Stagnant ice and age modelling in the Dome C region, Antarctica

Review 2 response

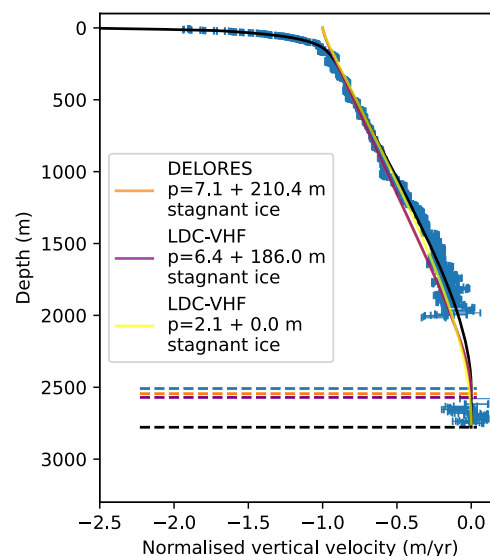
I am writing this as I am reading, so maybe this will pop up further below. Looking at Fig. 11 it seems to me that the fit in Lilien et al. 2021 which does not include H_m is very good already. Surely the standard

deviation becomes smaller with an additional tuning parameter, but I would argue that this alone is not yet a convincing statement without a physical explanation as to why such a layer would be present.

There is a stagnant ice layer present in Lilien et al.'s modeling work which is now present in Fig 13 (former fig 11) which is close to the LDC-VHF line in our work. We have now added the modelled result assuming no stagnant ice layer- note that we don't include uncertainties as we believe the deviation from the isochrone constraints alone is a clear argument against this model.

Sentence added new line 351:

For comparison, we show the age-depth profile determined using the model which does not allow for a stagnant ice layer (black line). The profile clearly deviates from the isochrone constraints (blue circles) at depths >2200 m, supporting the conclusion that the inclusion of a stagnant ice layer in the model is the more appropriate at LDC (Sec. 4.3).

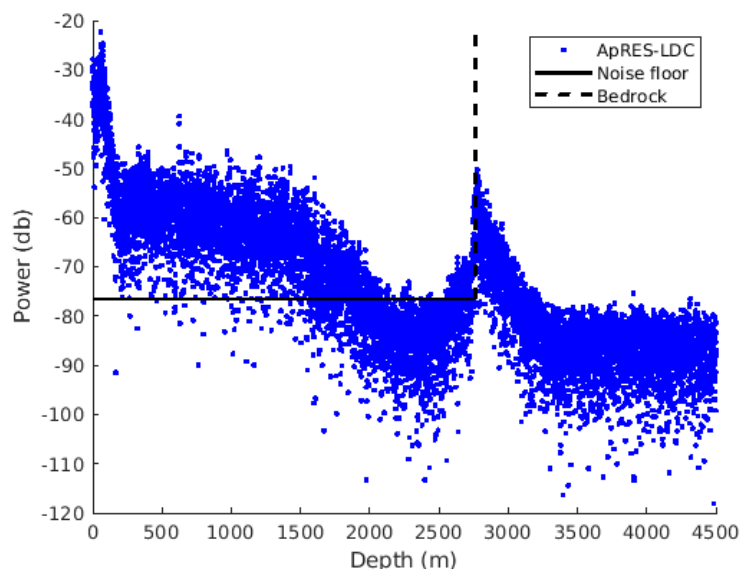
L262 comparing the vertical velocities at LDC and EDC at around 2000m the difference seems to be very small (maybe 0.1-0.2 m/a?). I don't know much about ApRES derived velocity uncertainties, but this seems to be somewhat narrow margins? Again, a more expansive discussion of uncertainties and potential alternative explanations would help a lot here.

We follow the standard ApRES uncertainty estimation technique described in Brennan et al. (2014) and Nicholls et al. (2015), where phase uncertainty depends on signal-to-noise ratio. Interestingly, the basal unit has a much higher signal-to-noise ratio than ice immediately on top of it. We show here a figure of the return power at ApRES-LDC location to illustrate this point.

We agree with the reviewer that we should describe in more detail the ApRES uncertainty and highlight the fact that uncertainty, that inversely relates to signal-to-noise ratio, is lower in the basal unit than in the ice above it. This is unusual as signal-to-noise ratio typically decreases with depth. We are rewriting the document to incorporate these points.

New line 226

We follow the standard ApRES uncertainty estimation technique described in Brennan et al. (2014) and Nicholls et al. (2015), where phase uncertainty depends on signal-to-noise ratio. The uncertainty inversely relates to signal-to-noise ratio and is lower in the basal unit than in the ice above it which is unusual as it typically decreases with depth.
